A D D E N D U M #2

Project	Nelson H.S. Renovations	**Project No.**	2323
Location	4181 New Street, Burlington, Ontario	**Date of Issue**	2024 05 30
Owner	The Halton District School Board	**File**	2323/7.1.3

This Addendum forms part of the Contract Documents and amends the original Drawings and Specifications, dated 2024 05 13, as noted below.

8 / A501 TYP. WINDOW COLUMN CLADDING SECTION DETAIL - IN 1963 CLASSROOM WING 1:5

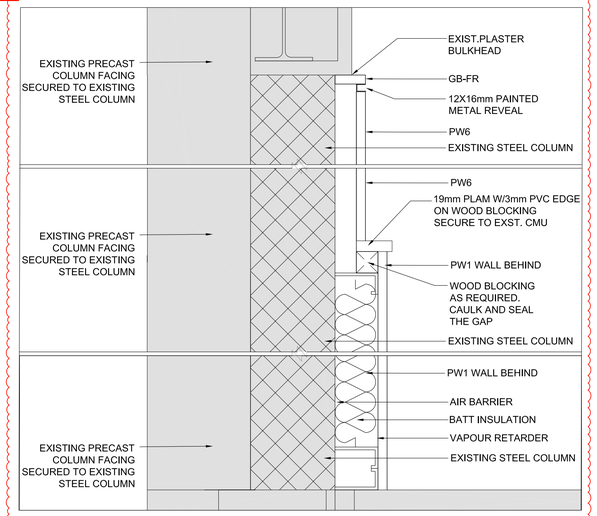
.2 Add detail no. 5 'Louver Section Detail at Lintel' and 8 'Typ. Window Column Cladding Section Detail'

1 / M3.1 PARTIAL GROUND FLOOR PLAN

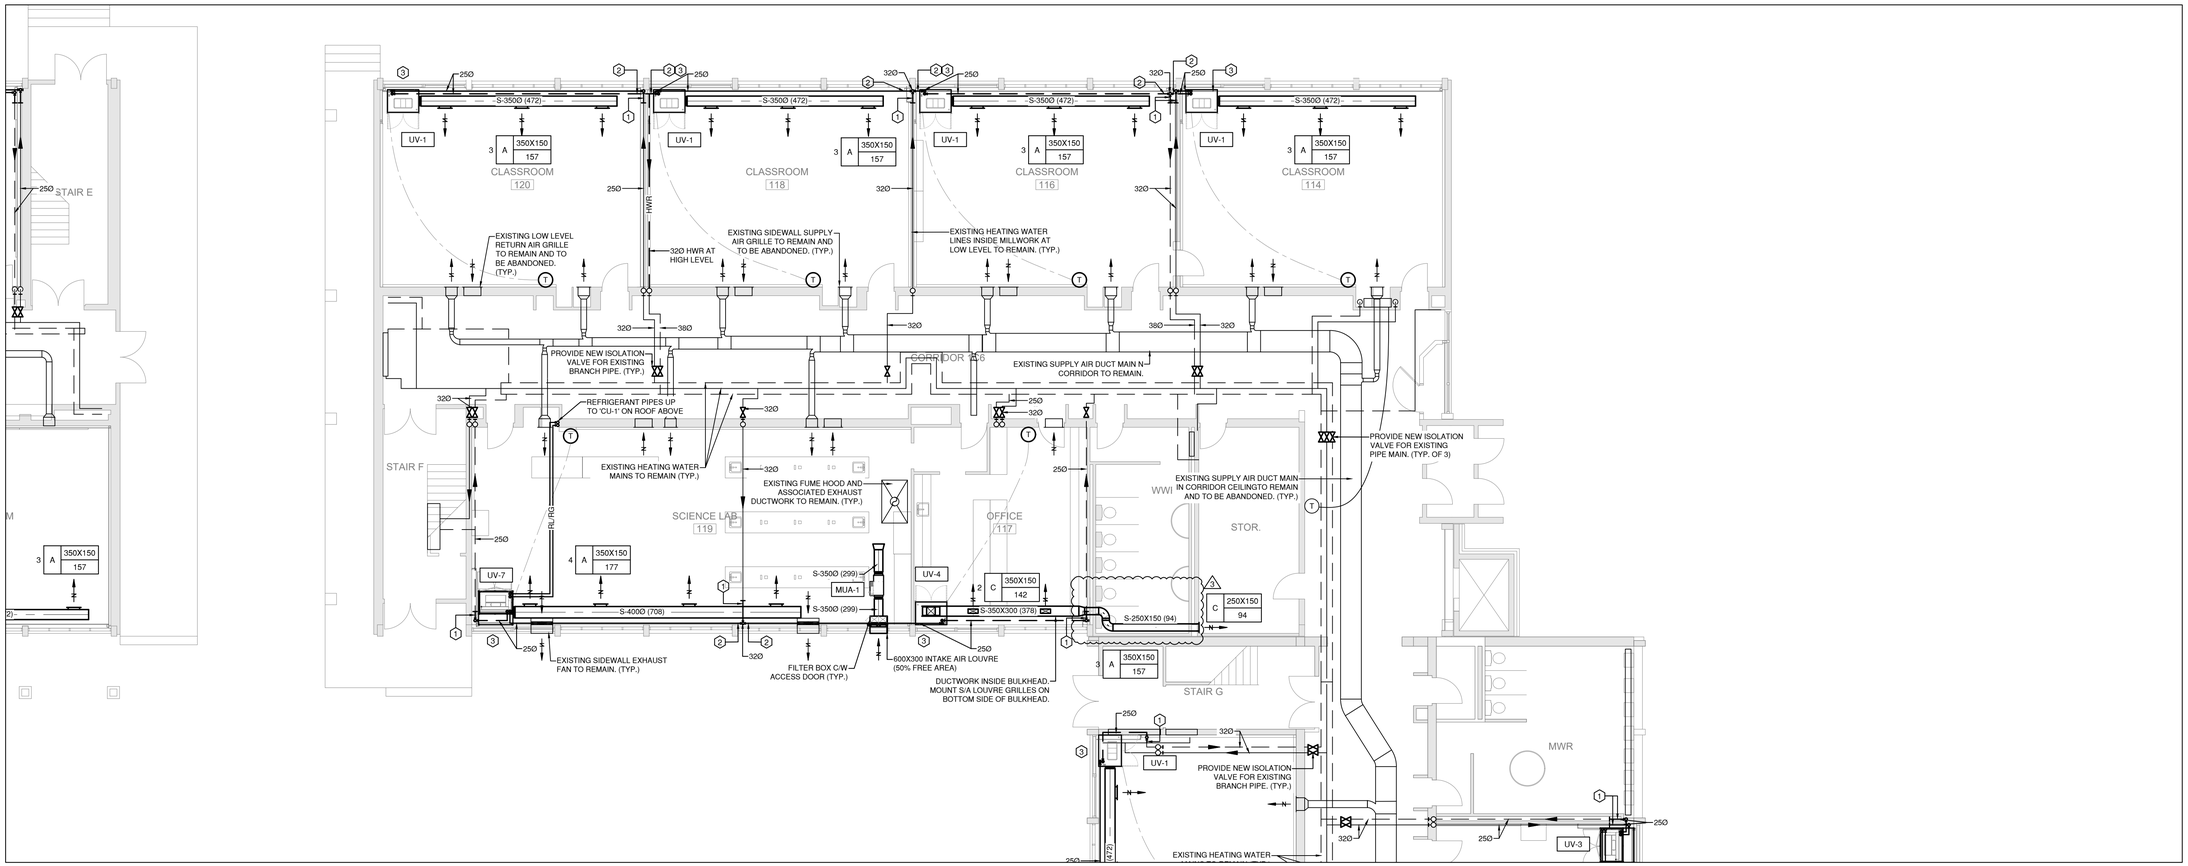
.1 Refer to detail 1, revise supply air duct routing in washroom adjacent Office 117 as indicated. Secure duct on side of wall.

1 / M3.3 PARTIAL GROUND FLOOR PLAN
Scale: 1:100

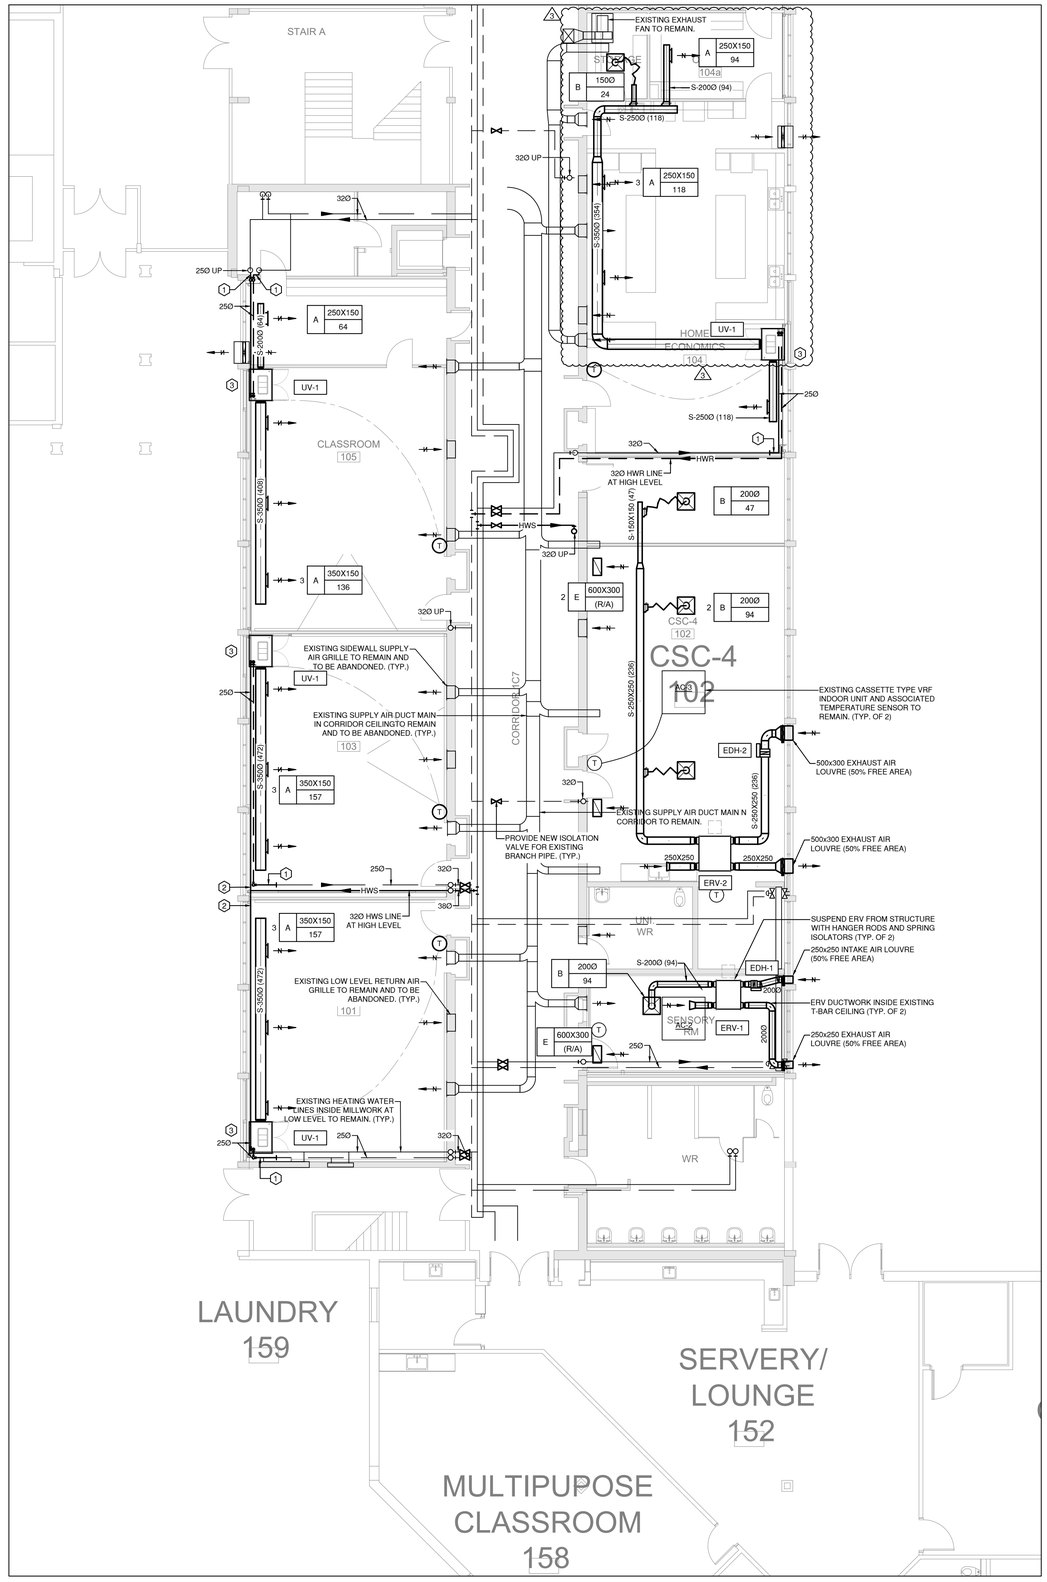
.1 Refer to detail 1, revise supply air duct routing in Home Economics Rm.104 as indicated.

1 M3.4 PARTIAL SECOND FLOOR PLAN
Scale: 1:100

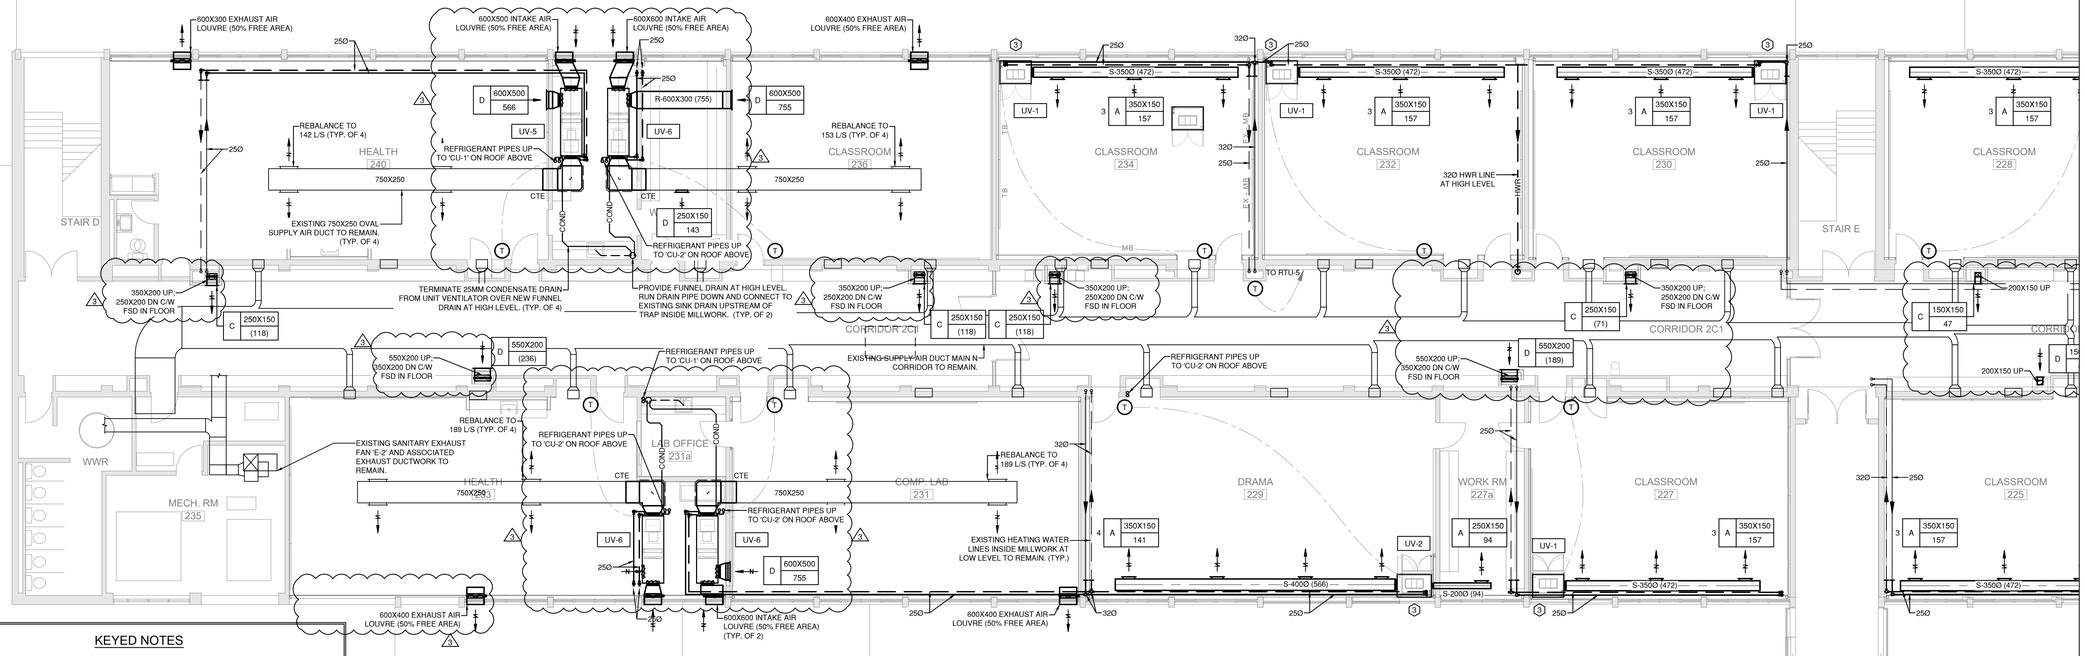
.1 Refer to detail 1, relocate exhaust air louvre in Health Rm. 233 as indicated.
.2 Refer to detail 1, shift intake air louvre and revise fresh air duct of unit ventilators in Rm. 231, 233, 236, and 240 as indicated.
.3 Refer to detail 1, revise condensate, heating water piping and refrigerant piping routing of unit ventilators in Rm. 231, 233, 236, and 240 as indicated.
.4 Refer to detail 1, provide fire smoke dampers for supply and return ducts penetrating floor assemblies in corridor 2C1 as indicated.
.5 Refer to detail 1, revise supply and return airflows in corridor 2C1 as indicated.

2 M3.4 PARTIAL SECOND FLOOR PLAN
Scale: 1:100

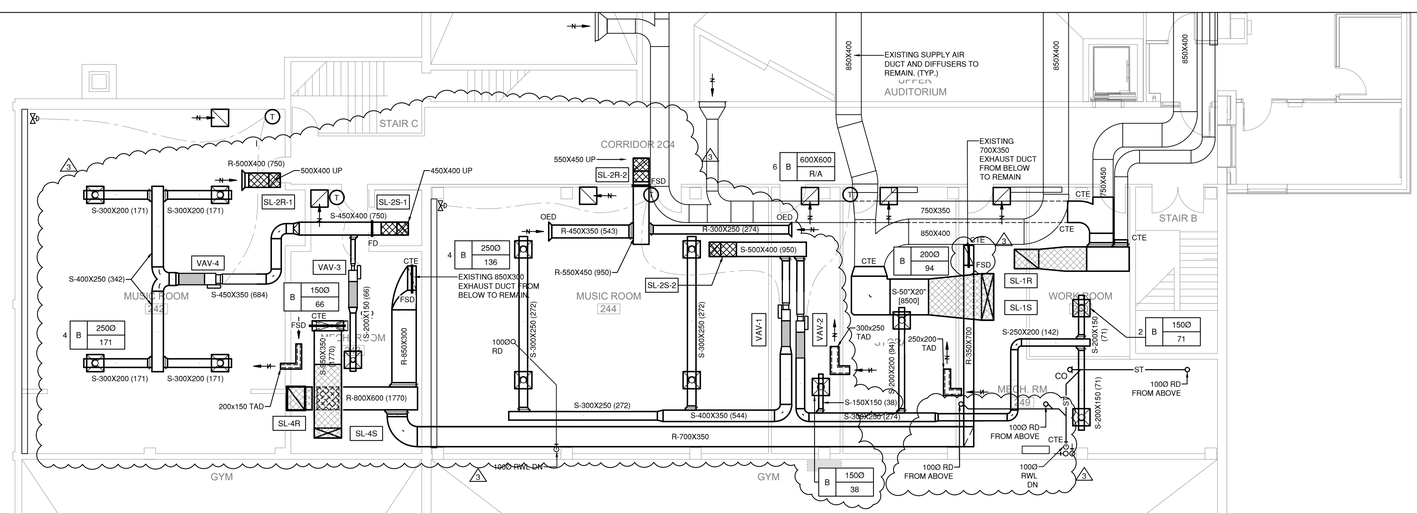
Q11 – Please confirm extent of storm pipe rerouting of existing roof drain and new roof drain on drawing M3.11

.6 Refer to detail 2, revise supply and return air drops and duct routing of RTU-2 (Music) in 2nd floor ceiling as indicated.
.7 Refer to detail 2, add storm piping from new roof drain above and revise storm pipe routing in Mech. Rm. 249 as indicated.
.8 Refer to detail 2, revise quantity, dimensions, and locations of supply and return silencers of RTU-2 as indicated.

A11 – Refer to detail 2 on drawing M3.4 issued with Addendum M-02

1 / M3.5 PARTIAL SECOND FLOOR PLAN

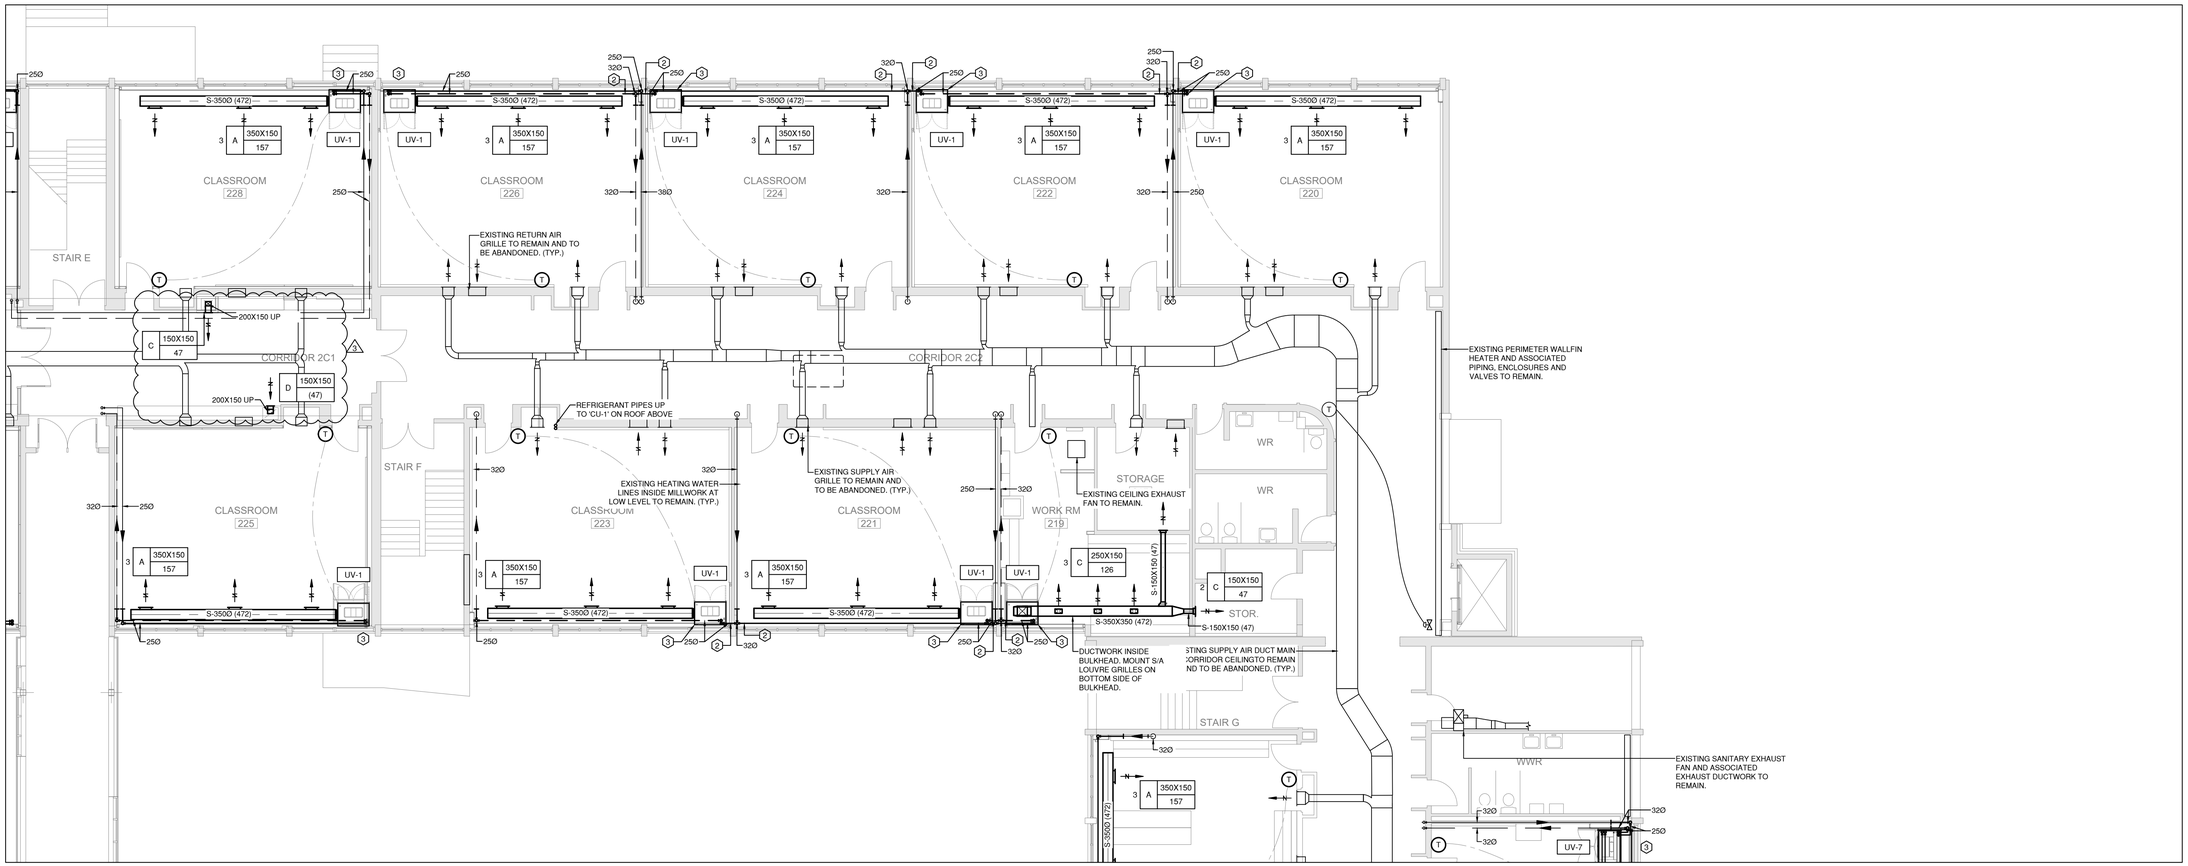
.1 Refer to detail 1, provide supply and return air ducts and grilles in corridor 2C1 as indicated.

1
M3.8
PARTIAL ROOF PLAN
Scale: 1:100

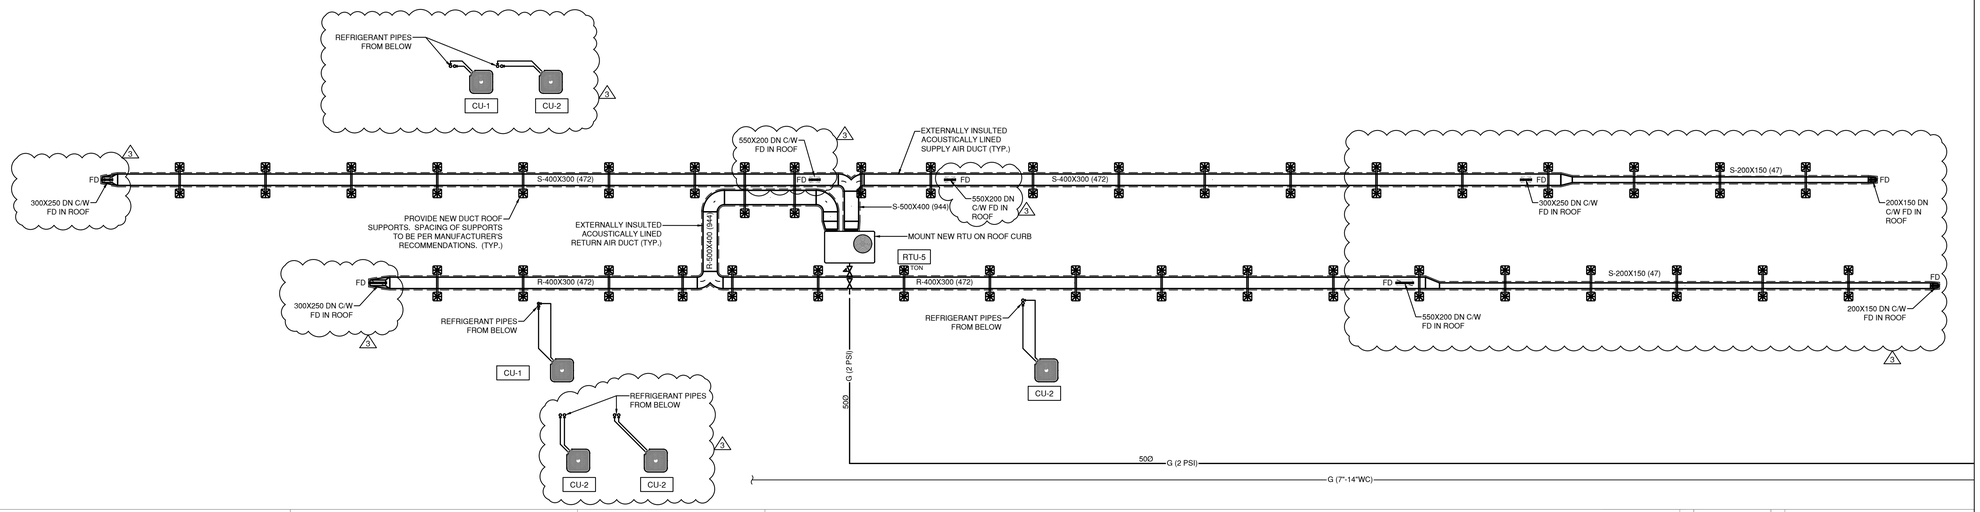
.1 Refer to detail 1, revise locations of refrigerant risers, condensing units and routing of refrigerant lines on roof as indicated.
.2 Refer to detail 1, extend corridor supply and return air ducts on roof and provide new duct drops as indicated.
.3 Refer to detail 1, provide fire dampers in supply and return air duct drops penetrating the roof assemblies as indicated.
